**FINAL
TECHNICAL EVALUATION REPORT
for the
PROPOSED REMEDIAL ACTION
at the
SPOOK TAILINGS SITE
SPOOK, WYOMING**

December 1989

**Division of Low-Level Waste Management
and
Decommissioning
U. S. Nuclear Regulatory Commission**

FIGURE 2.2

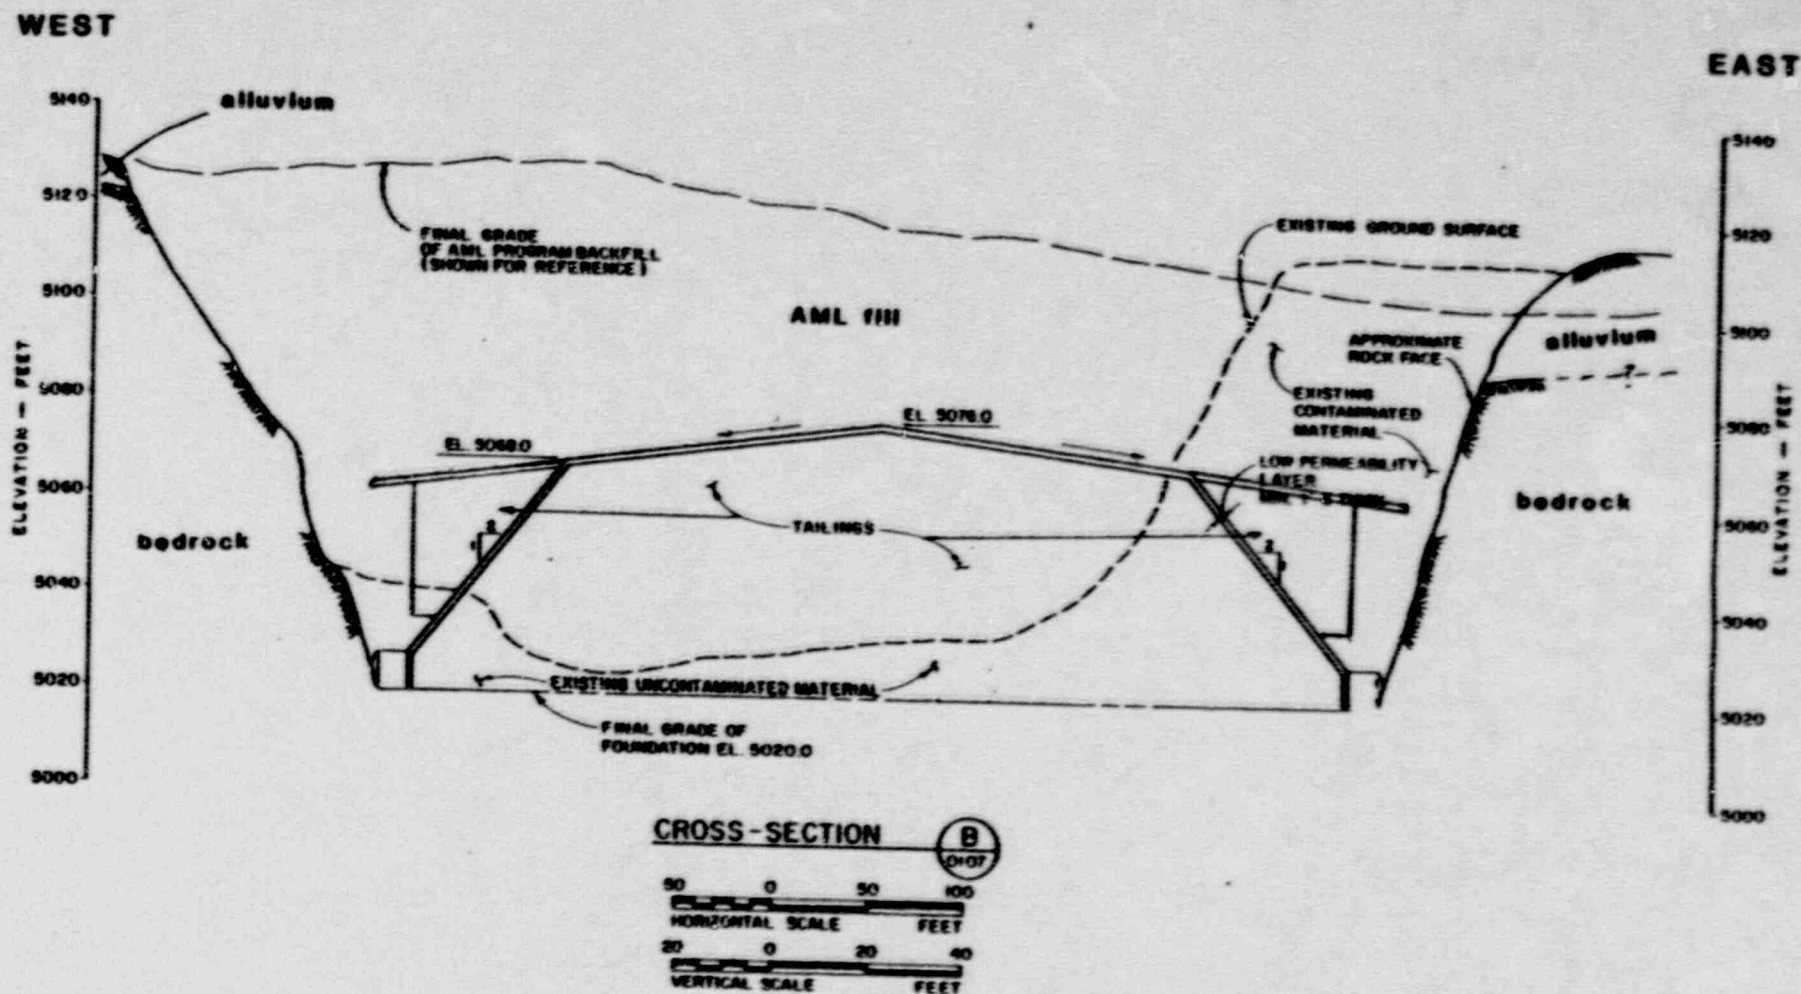
DOE asserts that bedrock occurs higher than the proposed tailings pile, and will provide a stable base level to prevent future downcutting and erosion of pit fill. The RAP and design provides an east-west cross-section to show the relations (Figure 2.2). The staff's review indicates that a more likely orientation of eroding channels would be from Spook Wash southward through the pit backfill (Figure 2.3). In this orientation, no bedrock occurs higher than the elevation of the proposed tailings pile. In addition, the staff observed (trip report, Reference 29) that the Wasatch sandstone rock appears to be poorly cemented and probably lacks the induration needed to provide a stable base level for long time periods. The staff concludes that the bedrock may not provide significant erosion protection, and that reasonable assurance of long-term stability of the tailings pile should be based on other aspects of the site and design.

The low-permeability cover layer will be 1.5 feet thick and will be placed on the tailings disposal cell as shown in Figure 2.2. The disposal cell will be surrounded by and buried in the AML Program backfill. The contract documents state that both the UMTRA Project and AML Program work will be constructed by a single subcontractor. The compaction requirement for the cover is 95 percent standard proctor, whereas the requirements for the tailings and AML Program backfill are 90 percent standard proctor. Placing a thin layer (cover layer) between two different materials and maintaining a 50 percent slope for the thin layer will require special care during construction. The planned construction sequence as DOE has shown on Drawing SPK-PS-10-0109 (Reference 4), is acceptable to the staff, as a means for assuring the required minimum thickness of the low-permeability cover layer.

As a result of discovery of an additional 50,000 cubic yards of contaminated material, DOE proposed a modification to the cell design. Placement of the additional material was limited by the need to remain within the existing cell footprint and the need to accommodate geomorphic considerations by not increasing the pile's elevation. The proposed modification consisted of placement of the additional material on the east and west sides of the pile and extending the low-permeability cover across the top of the material to 20 feet beyond the cell footprint (see Figure 2.2 and Section 3.1).

FIGURE 2.3

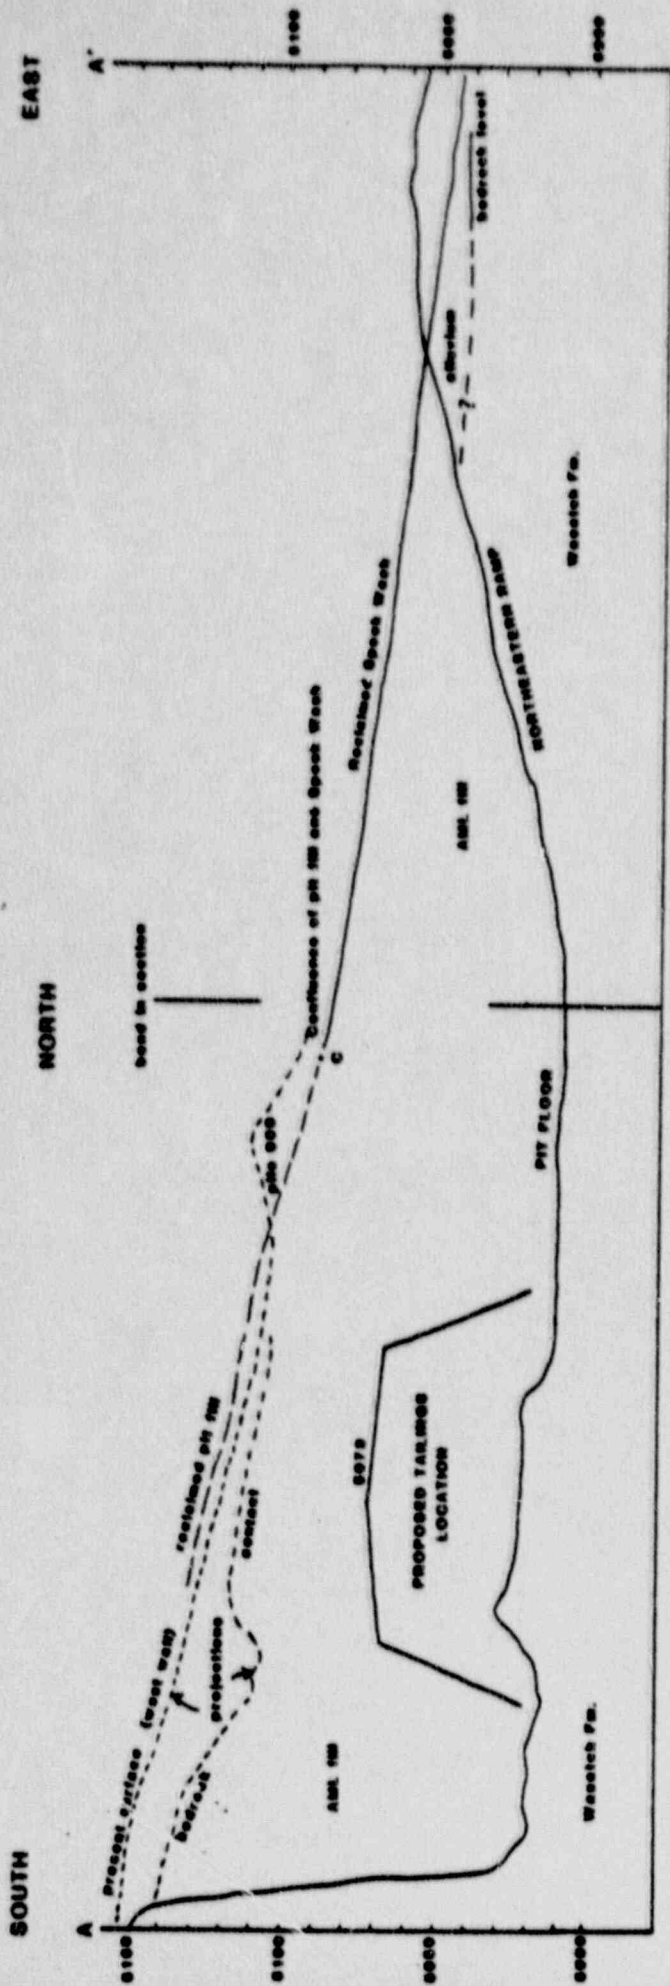
others in the western United States for which gully threshold conditions have been established (Reference 15; Figure 3.9). Our analysis shows that the Spook basin is similar to other semiarid basins which have not experienced gully formation. The basin's area and gradient also lie below a statistically derived threshold for gullying determined from those semiarid basins. The staff concludes that while hillslope and channel erosion are likely to occur over the long term, widespread gully growth is unlikely. Therefore, the design provides reasonable assurance that drainage channels will not affect the long-term stabilization of the tailings pile.
